37
From: WJ Shack <wjshack@anl.gov> Argonne Nat. Lab
To: Allen Hiser <ALH1@nrc.gov>, Ed Hackett <EMH1@nrc.gov> NRR
Date: 11/4/01 9:47PM
Subject: One last shot

Figure 10. Estimated stress intensity factors K_{est} for a CRDM nozzle. The conservative estimate of K developed in Section 6.4.2 is denoted as $K1$.

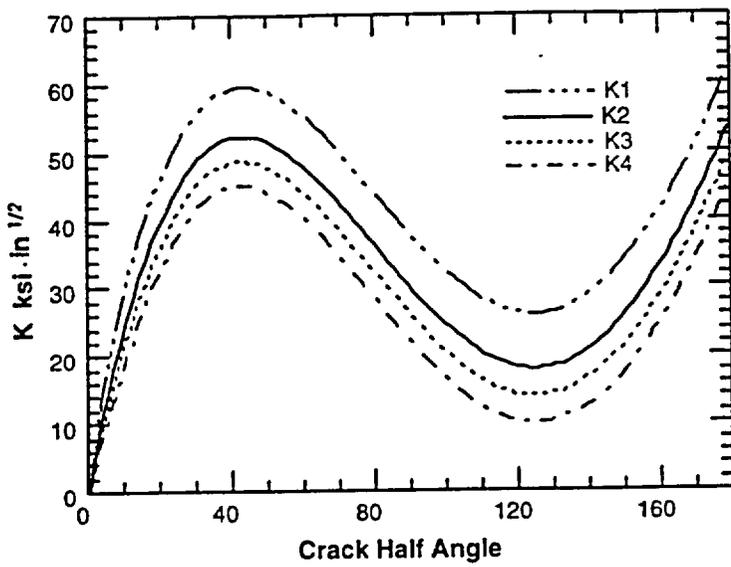
The two big factors in POF are plant to plant variations (about a factor of 20) and variation with K (about 4 orders of magnitude). In fact the POF changes more than 3 orders of magnitude with a change in K of 4 ksi in^{0.5}.

The variation from plant to plant is real. The variation with K is artificial. It arises from the assumption that all 69 nozzles have the same K. What we don't know and what seems like the highest priority to determine is what fraction of the nozzles have the high Ks and what fraction have low Ks. We will have to see what SIA, Gery, and Richard can do.

There is a kind of threshold behavior that is related to the steep part of the Scott curve. Three of my K distributions which drop the lowest K from 25 to 14 result in a change for Oconee of about a factor of 4 from 0.39 to 0.09. The next drop in the minimum K from 14 to 10 drops the failure probability by orders of magnitude. Conversely it would only take a relatively few high stress nozzles to get Oconee3 up to about 0.1 at 20 EFPY. Most other less susceptible plants would be 0.01 or lower.

Figure 13.
Variation of the cumulative probability of failure with EFPY assuming all nozzles have the K1 distribution.

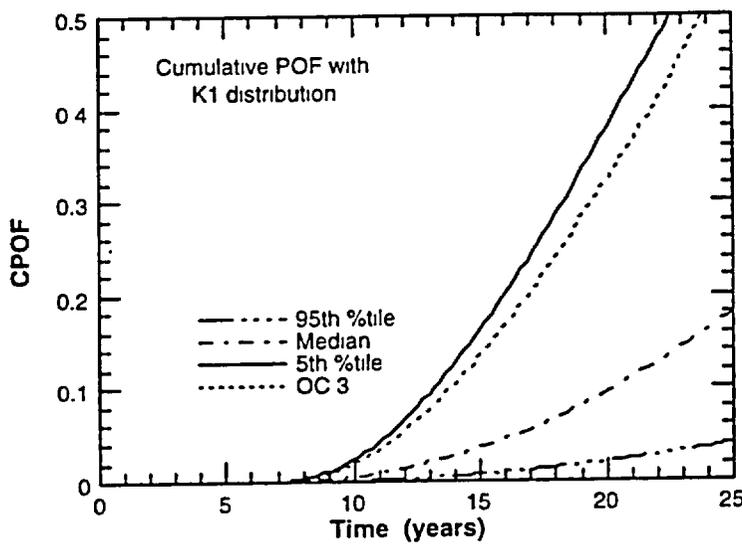
The calculations with the bounding K acting on all 69 nozzles give probabilities that range from 0.39 for Oconee 3 (close to the 95th percentile plants) to 0.02 for other plants. The rate of increase in the CPOF for the 5th, 50th, and 95th percentile plants with this bounding K are 0.04, 0.013, and 0.003 per EFPY.
